**PRELIMINARY FINDINGS OF THE
INDEPENDENT PEER REVIEW PANEL
FOR SEISMIC HAZARD STUDIES AT
DIABLO CANYON**

Chris Wills
California Geological Survey,
Chair, IPRP

California Energy Commission Joint Commissioner Workshop
April 27, 2015

Dip of the Los Osos fault:

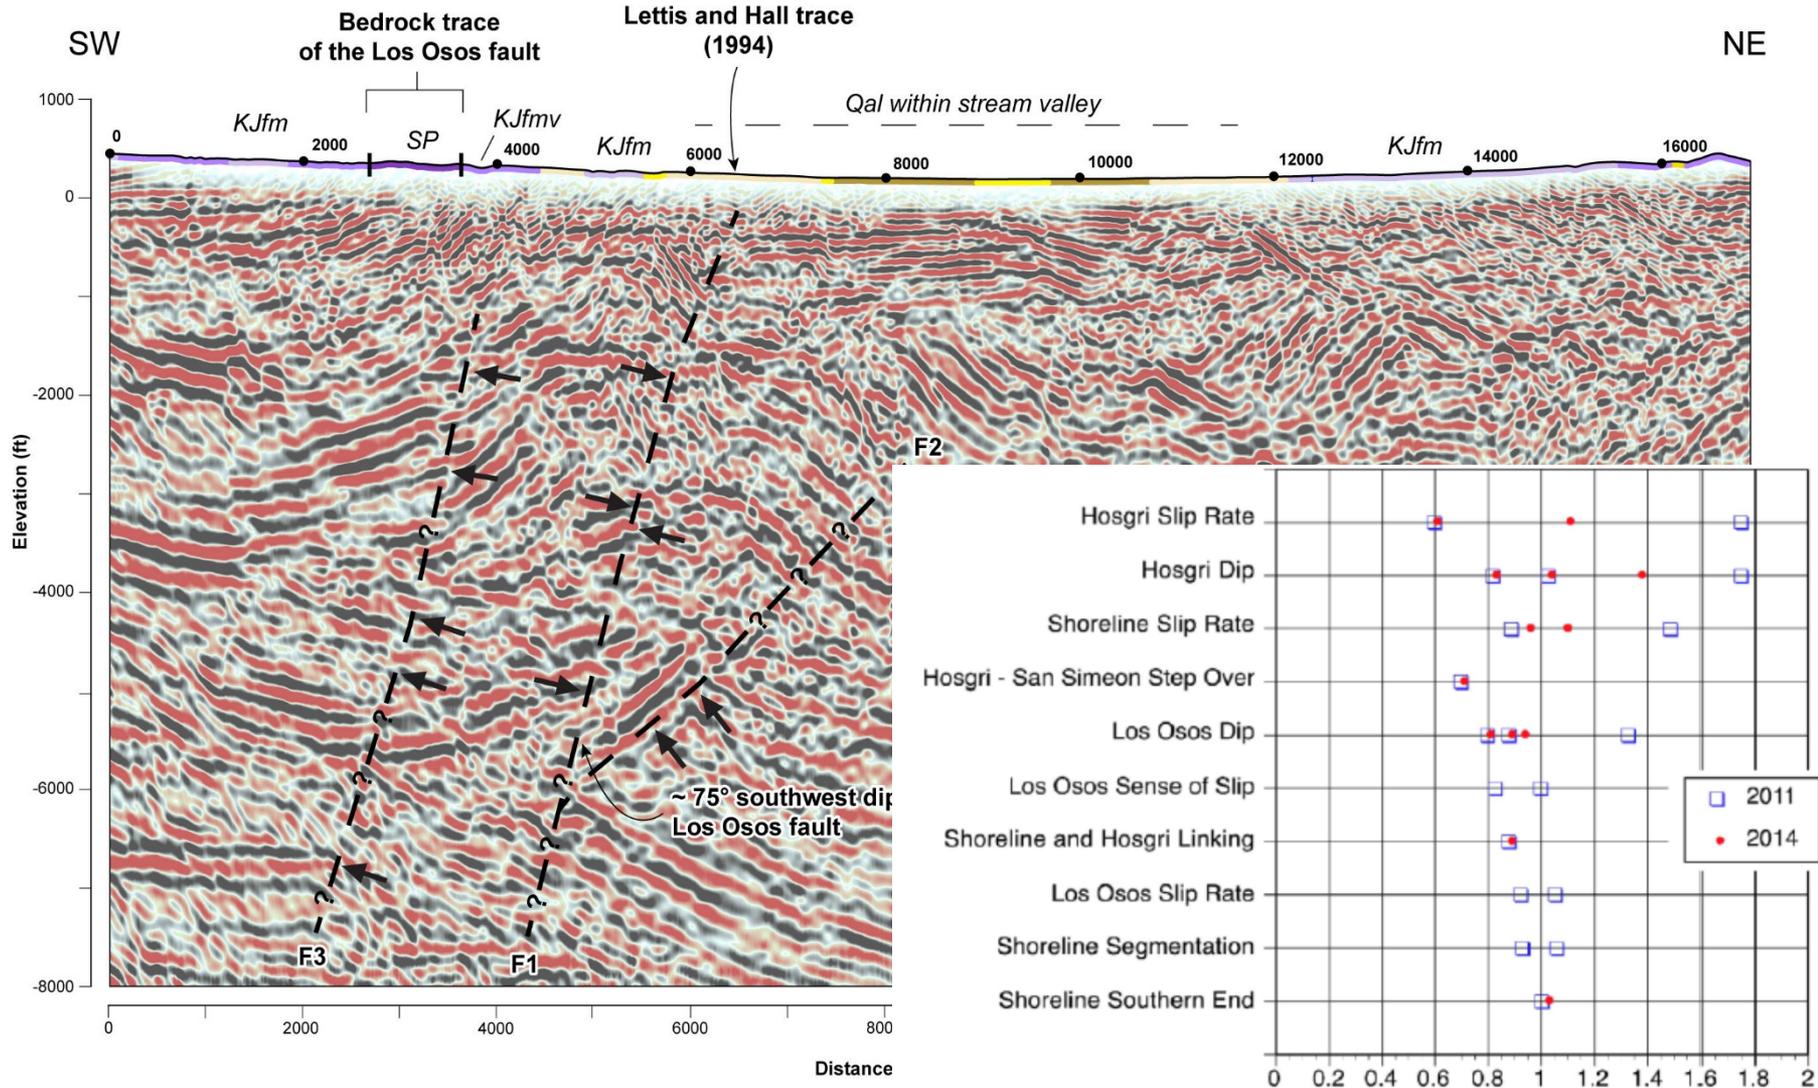
Reflection seismic surveys do not provide convincing constraints on geometry of subsurface faults

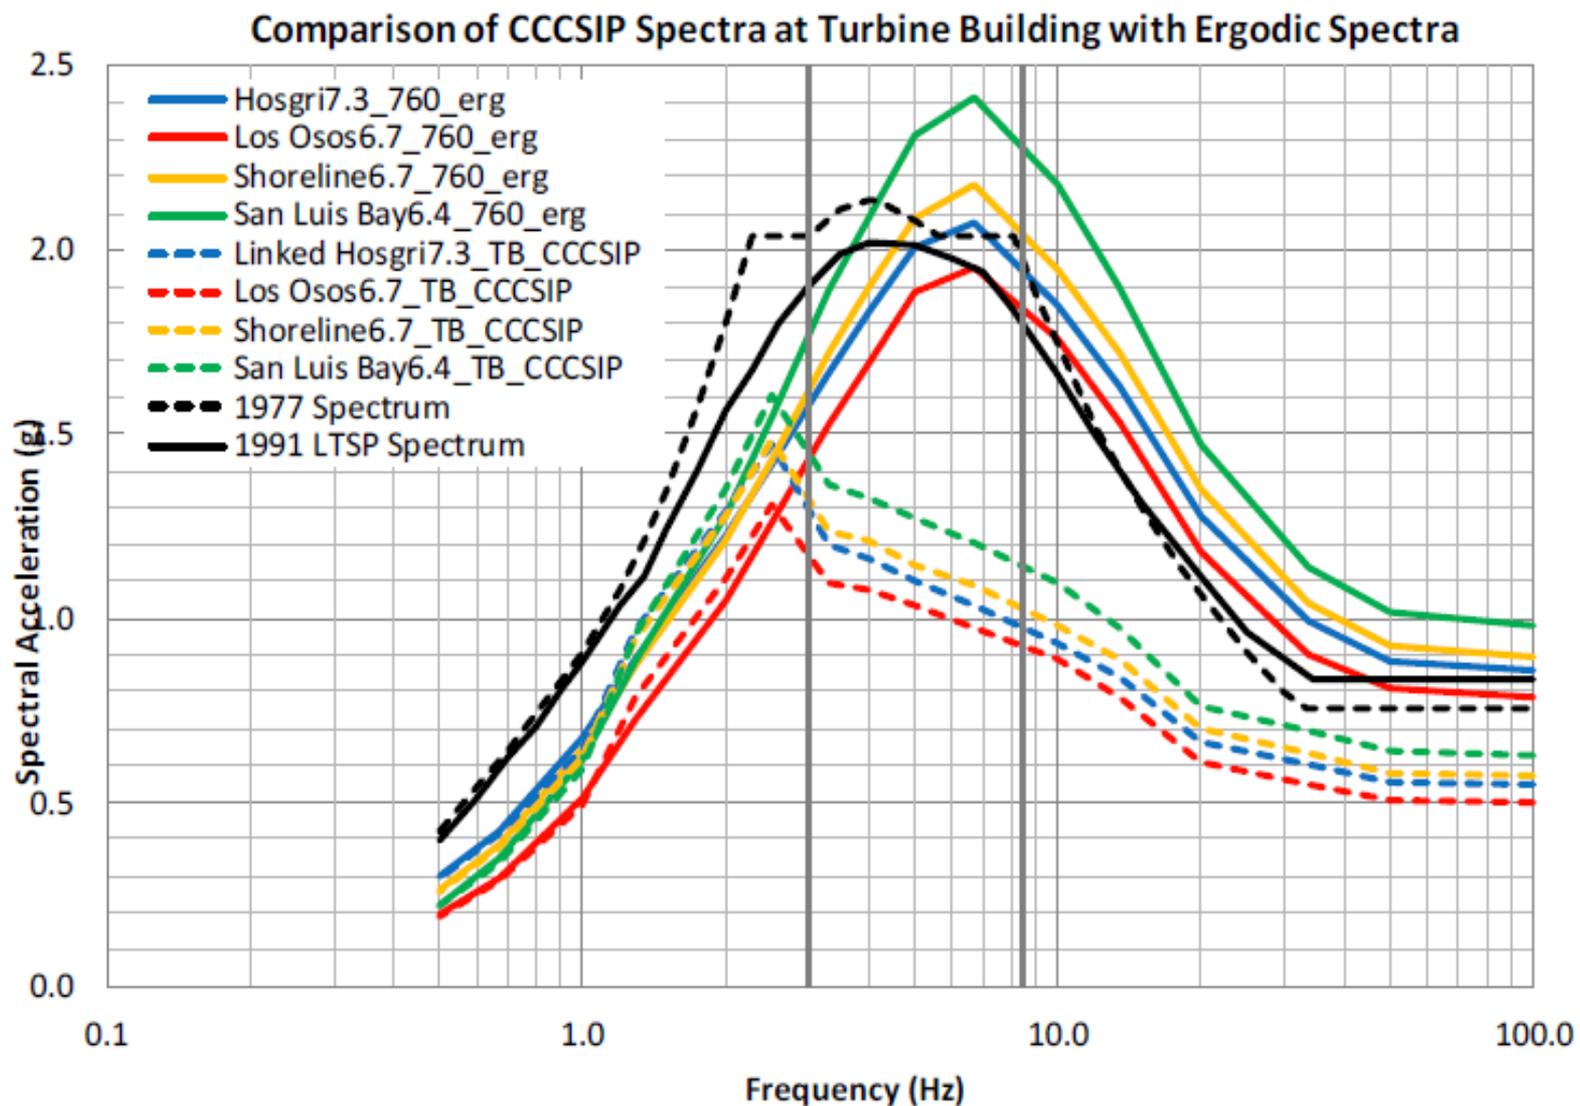
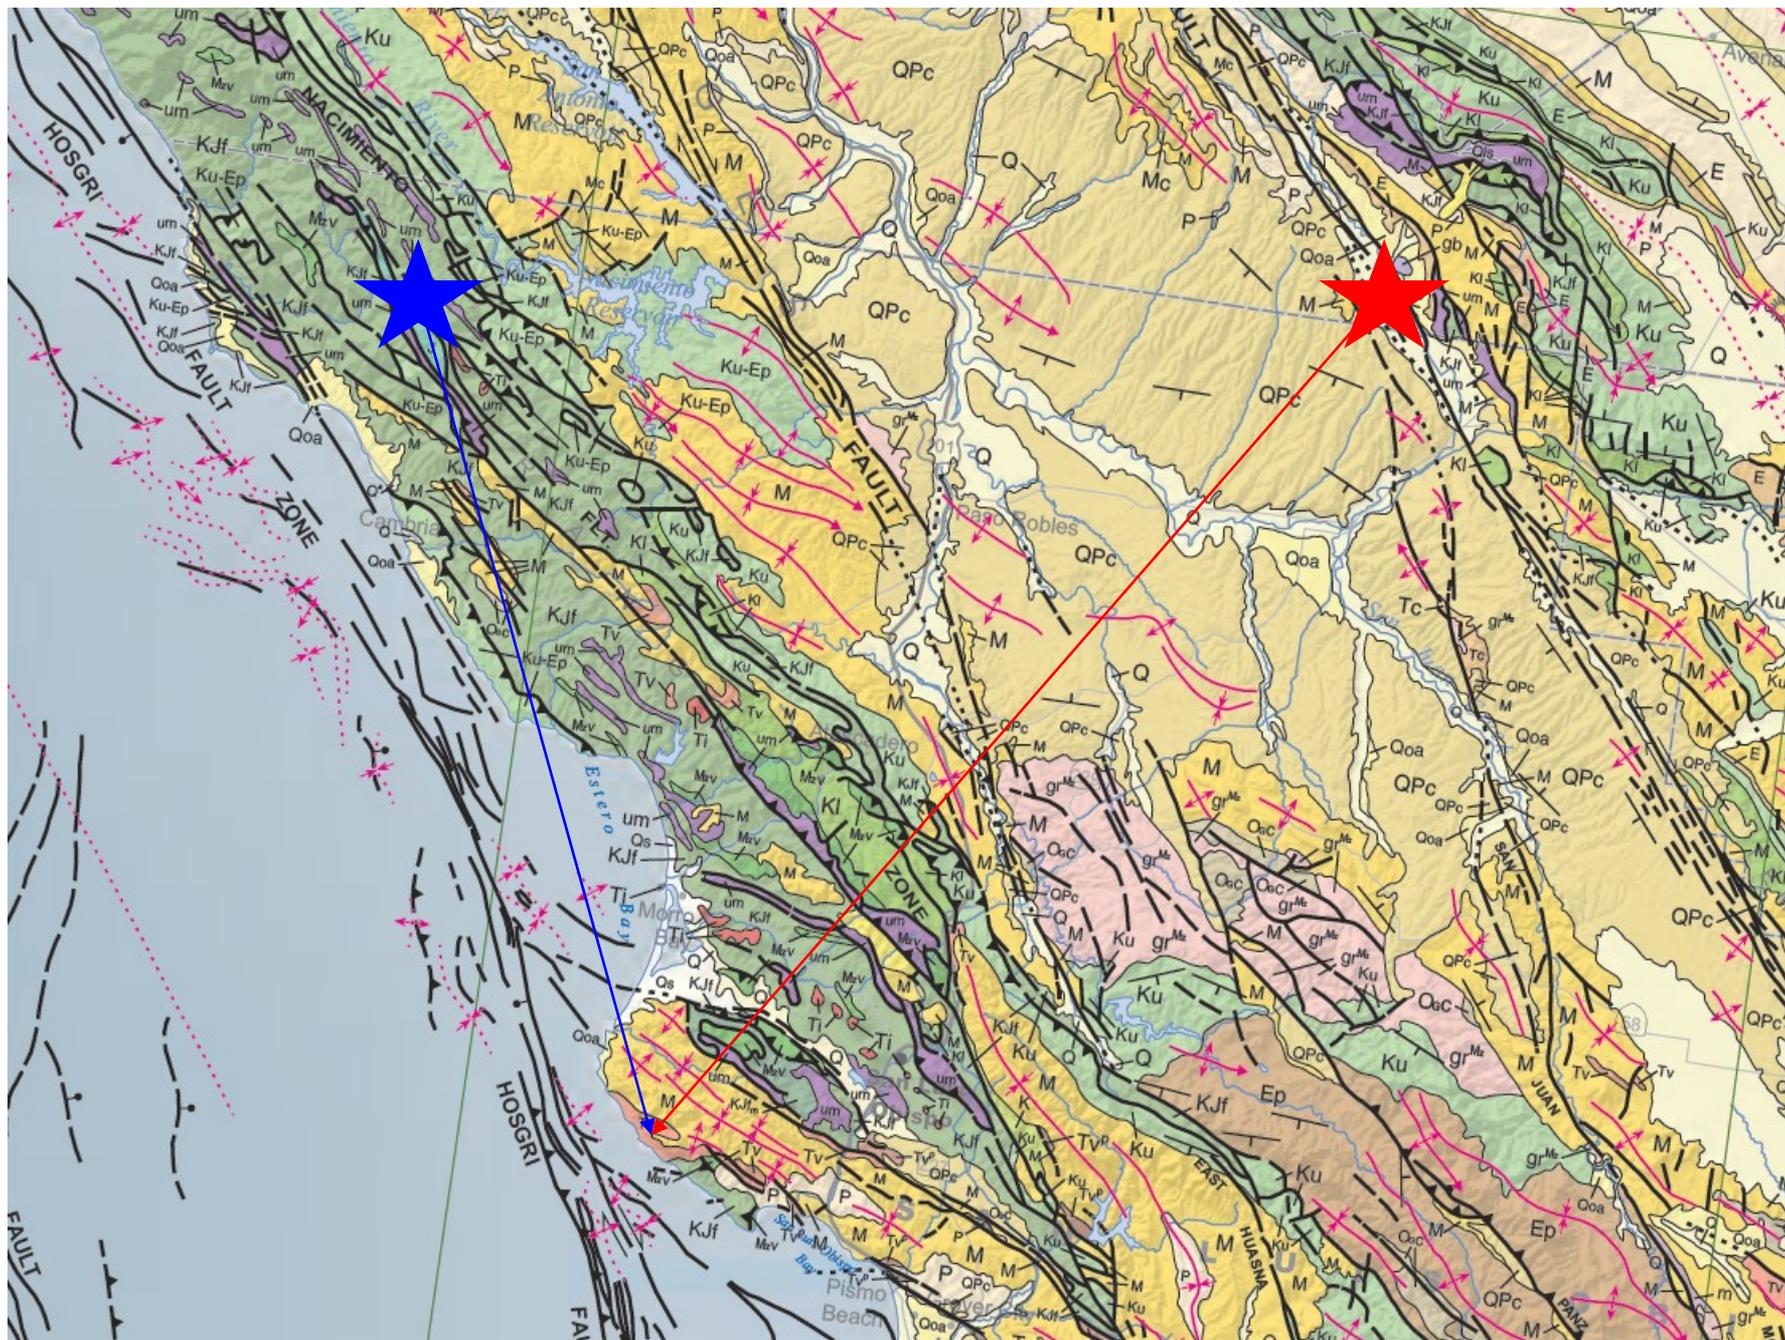
An empirical site amplification factor has been developed by PG&E to explain relatively low ground motions from the San Simeon 2003 and Parkfield 2004 earthquakes. If this factor is due to some intrinsic properties of the site, then it would apply to any earthquake.

If the “site term” does apply to all earthquakes, it would change the shape of the response spectra and substantially lower shaking hazard in the range of frequencies of most concern to DCP

PG&E indicated that they plan to conduct further studies to improve the quantification of site amplification:

1. PG&E will use new data from recently completed on-land exploration geophysics surveys to develop a new model of Vs beneath the plant site.
2. PG&E will analyze broad band ground motion data to rule out path effects in the current site-specific amplification terms. Since data from two earthquakes are not sufficient to demonstrate that the amplification factors include only modifications of the shaking due to site effects, recorded motion from other earthquakes, particularly earthquakes from the south and west, may help rule out path effects in the amplification terms.
3. PG&E will evaluate site amplification using analytical approaches in which seismic waves are propagated through a velocity model.
